Transport Assessment

State Significant Development Application – Modification

657-769 Mamre Road, Kemps Creek (SSD-9522) Modification

TABLE 2 RESPONSE TO TFNSW COMMENTS – EMAIL OF 3 NOVEMBER 2021

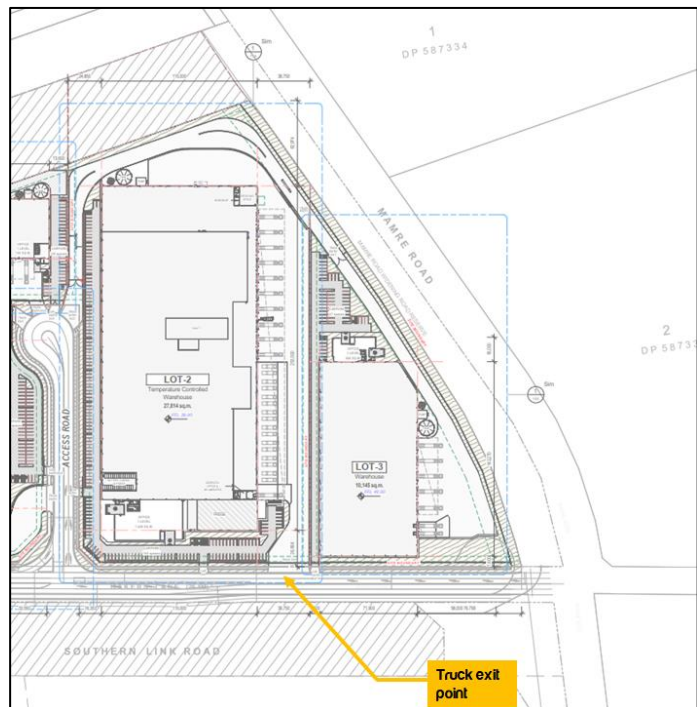
- 3 Access closest to Mamre Road – in order for a 26m B-double to undertake the turn they would need to undertake the turn from the wrong side. Any access to should be able to accommodate for simultaneous entry/exit.

It is noted that the heavy vehicle access point shown in the following figure is the closest to Mamre Road.

It is important to note that this access point is a heavy vehicle exit point only for Lot 2 (which does NOT ACCOMMODATE ENTRY movements). Therefore, 26.0m B-double trucks will not undertake entry movements for Lot 2 (from this access crossover). Based on the swept path analysis included in **Appendix D**, this exit movement can occur in a lane correct manner. A reduced copy is also re-produced overleaf.

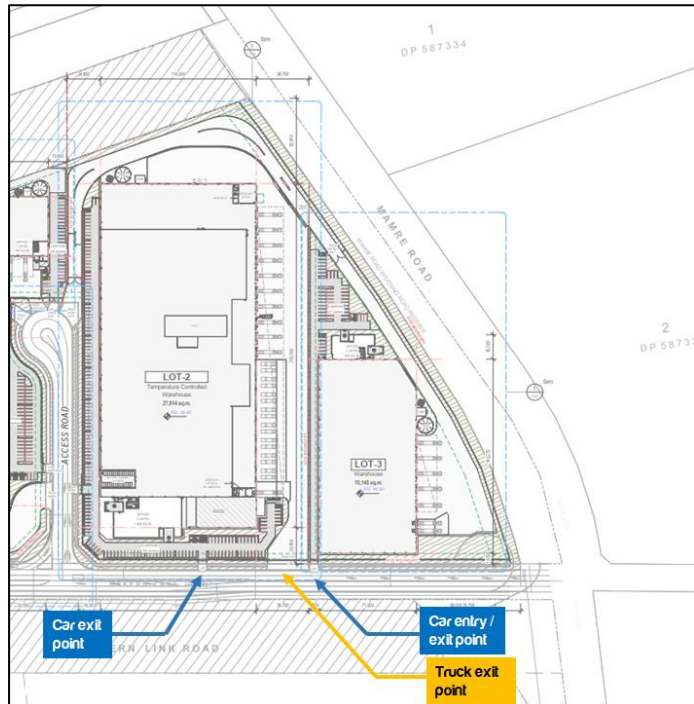
- 4 3 driveways shown in close proximity (closest to Mamre Road) – light access, heavy access and light access – concern with conflicting movements, swept paths missing.

The three closest access points to Mamre Road are shown in the figure below.

With regards to the western light vehicle access point and the heavy vehicle access point, they will be restricted to exit only. Therefore, light vehicles and heavy vehicles will not undertake turns from the wrong side of Bakers Lane to enter the respective Lots. Furthermore, both light vehicles and heavy vehicles will exit this access point in a lane correct manner which suggests that the access crossover design is suitable for the respective design vehicle.
